**PLANNING APPROVAL &
SUBDIVISION STAFF REPORT****Date: May 19, 2011**

<u>NAME</u>	Plantation Memorial Gardens Subdivision
<u>SUBDIVISION NAME</u>	Plantation Memorial Gardens Subdivision
<u>LOCATION</u>	5501 Bear Fork Road (South side of Bear Fork Road at the South terminus of Jarrett Road)
<u>CITY COUNCIL DISTRICT</u>	District 7
<u>PRESENT ZONING</u>	R-1, Single-Family Residence District
<u>AREA OF PROPERTY</u>	1 lot / 25.0 acres \pm
<u>CONTEMPLATED USE</u>	Planning Approval to allow a cemetery with 21,250 plots in an R-1, Single-Family Residential District, and Subdivision approval to create one lot.
<u>TIME SCHEDULE FOR DEVELOPMENT</u>	Phase One, one year Phase Two, the remainder of parcel, within seven years
<u>ENGINEERING COMMENTS</u>	Must comply with all storm water and flood control ordinances. Any increase in impervious area in excess of 4,000 square feet will require detention. The proposed detention pond will need to be sized to provide at a minimum, detention from a 100 year storm with a 2 year release rate as outlined in the storm water ordinance. Any work performed in the right of way will require a right of way permit in addition to any required land disturbance perm

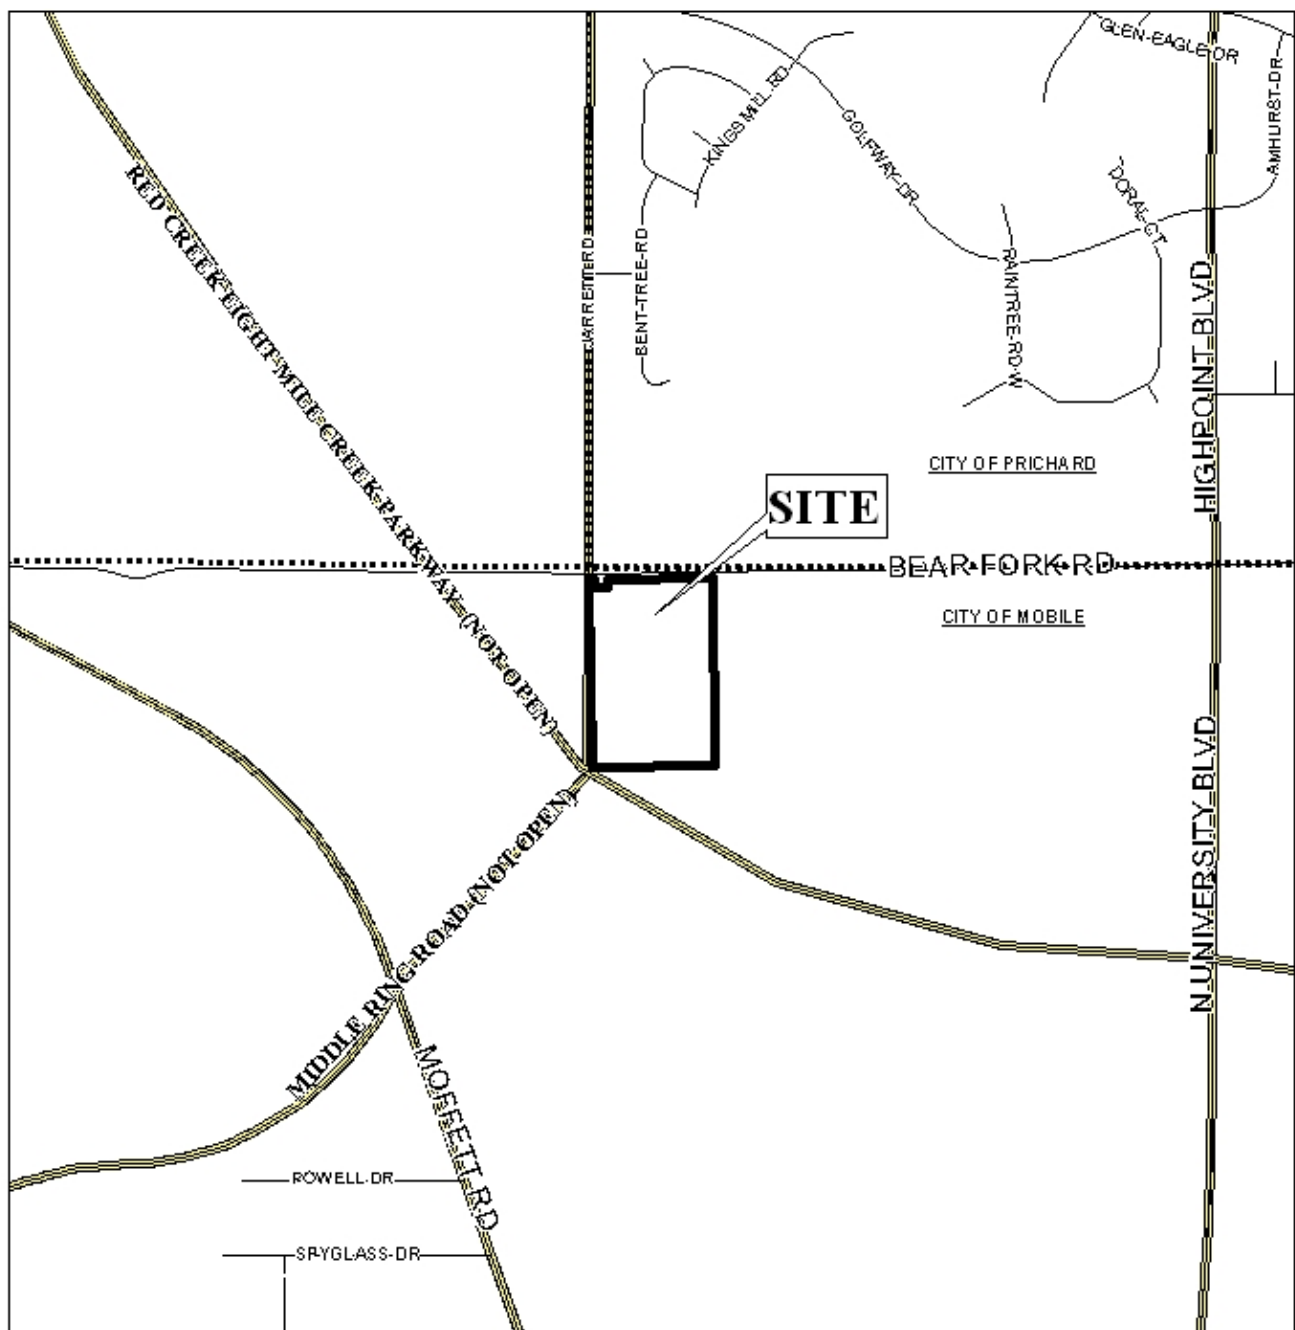
While Bear Fork Road is a minor street, access management is a concern. The site plan depicts one curb-cut onto Bear Fork Road, although the proposed lot has nearly 900 feet of frontage onto Bear Fork Road. To ensure consistency with the submitted site plan, the proposed lot should be limited to one curb-cut to Bear Fork Road, with the size, design and location to be approved by Traffic Engineering and Planning, and to comply with AASHTO standards.

As a commercial development, full compliance with the tree and landscaping requirements of the Zoning Ordinance will be required. The site plan depicts fairly extensive landscaping along Bear Fork Road, however, no landscape or tree calculations are provided. As the majority of the cemetery will be sod, landscape area should not be an issue. Due to the extensive frontage and perimeter, however, the provision of an adequate number of frontage and perimeter trees is questionable, thus the site plan should be revised to indicate the provision of required trees, or existing trees that will be retained for credit.

Due to the proposed use of the site as a cemetery, buffering should be provided. A minimum of a 10-foot wide landscape buffer should be provided where the site abuts R-1 property, and due to the size of the property, this buffer can remain as a natural vegetative buffer. If the applicant intends to place a fence and gates on the site, the site plan should indicate the location of the fence and gates, as well as the proposed height.

Finally, the 25-foot minimum building setback line is not depicted on the plat, however it is partially depicted on the site plan. The plat and site plan should be revised to depict the 25-foot minimum building setback line along both Bear Fork Road and the proposed Middle Ring Road right-of-way.

- 2) Revision of the site plan to depict the 25-foot minimum building setback from both the Bear Fork Road and proposed Middle Ring Road frontages;
- 3) Revision of the label for Middle Ring Road to depict the future right-of-way as being dedicated to the City of Mobile, or as a setback, in addition to the 25-foot minimum building setback;

- 4) Revision of the site plan to depict any fencing or gates proposed, to include the height of the proposed fencing;
- 5) Compliance with Traffic Engineering comments (*Driveway number, size, location, and design to be approved by Traffic Engineering and conform to AASHTO standards. Driveway shown is 60 feet in width. Narrow the driveway to a standard width of 24 feet*);

- 7) Depiction and labeling of a 10-foot wide natural vegetative buffer where the site abuts residentially-zoned property.
